UNITED STATES PATENT AND TRADEMARK OFFICE

10/573,703

Karl Krug-Kussius

DETAILED ACTION

4,289,160

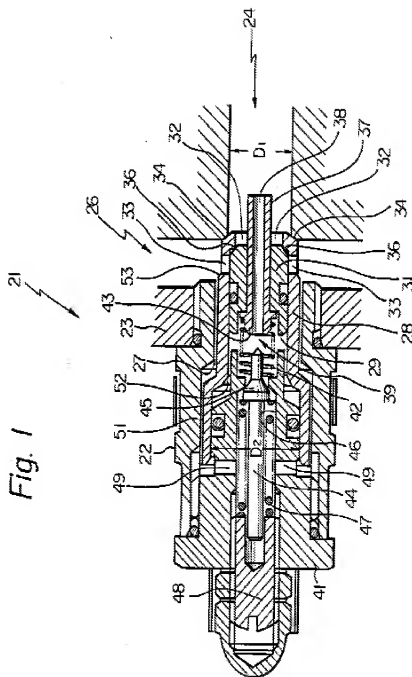
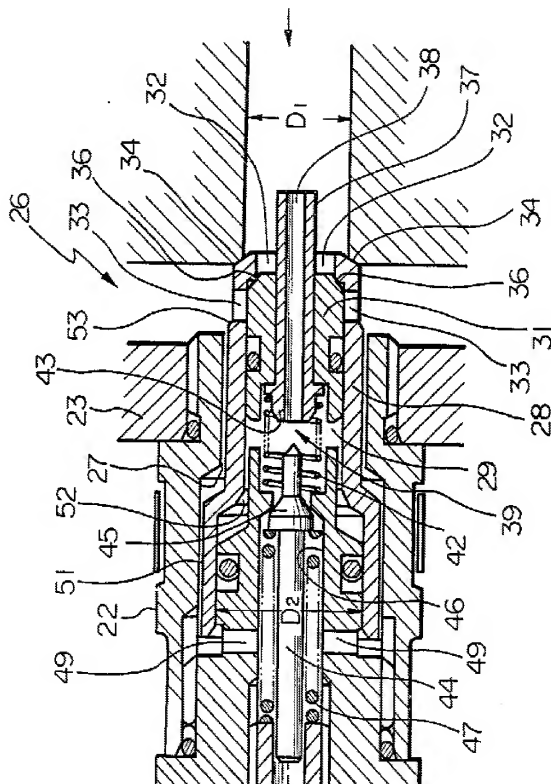
With regard to claim 1, Kawasaki discloses a pilot-controlled pressure feed valve, comprising a piston (31) of a main stage whereby a connection between an input port (24) and an output port (26) may be controlled open, and the spring chamber (39) of which is adapted to be connected with the input port via a piston bore (38) and with a control oil drain (51) via a pilot control stage

(49), characterized by a throttle valve means (37, 43, 45) which throttles a control oil flow through the piston bore from the input port into the spring chamber in a closed position (broadest reasonable interpretation of "closed position" includes the position in which end 43 of element 37 is approaching element 45), and controls open a comparatively large cross-section of flow in the anti-cavitation function (that position illustrated in FIG 1) in the event of a control oil flow in the opposite direction (although the anti-cavitation function of Kawasaki is performed primarily by the movement of element 28, any void formed in inlet 24 would also be replenished by fluid from the spring chamber).
